• **SUSPENSION—POP/CLUNK NOISE FROM THE FRONT SPRINGS OVER BUMPS OR WHEN TURNING—DEBRIS ACCUMULATION IN SPRING SEAT—CANADA VEHICLES ONLY** • **NOISE—POP/CLUNK NOISE FROM THE FRONT SPRINGS OVER BUMPS OR WHEN TURNING—DEBRIS ACCUMULATION IN SPRING SEAT—CANADA VEHICLES ONLY**	**Article No. 02-15-2**

FORD: 1996-2003 WINDSTAR

Figure 1 - Article 02-15-2

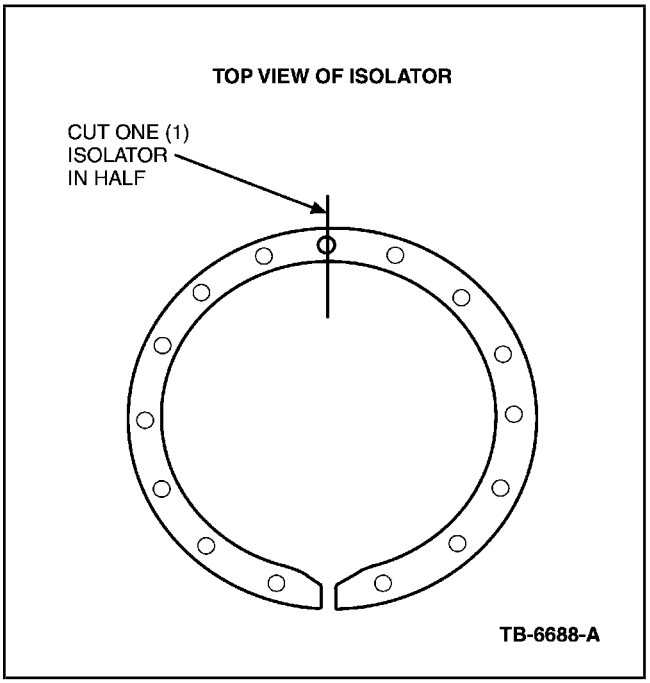
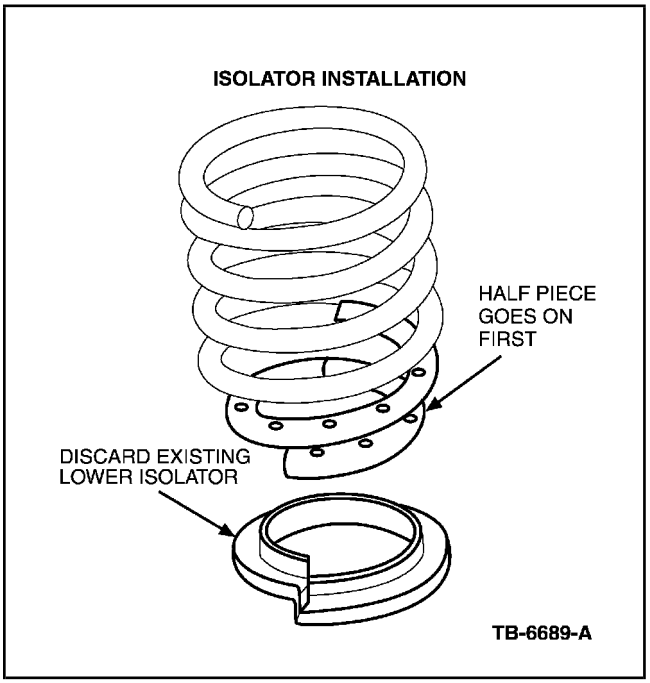
Some vehicles may exhibit a popping/grinding noise from the front of the vehicle when going over bumps or making turns. This may be caused by stones or debris building up on the front strut lower spring seat.

1. Remove the front springs per Section 204-01 (1999-2003) or Section 04-01 (1996-1998) of the appropriate model year Workshop Manual.
2. The existing rubber isolator (5414) on the lower spring should be removed and discarded.
3. The service repair requires 3 rubber isolators 3F2Z-5414-AA, per vehicle. Each front spring requires 1 1/2 isolators. One of the three isolators should be cut in half (Figure 1).
4. The half piece (180 degree arc) should be installed on the coil first, starting at the lower end.
5. The full piece (360 degree arc) should be installed in the spring starting where the first piece ended (Figure 2).
6. Re-assemble per Section 204-01 (1999-2003) or Section 04-01 (1996-1998) of the appropriate model year Workshop Manual.
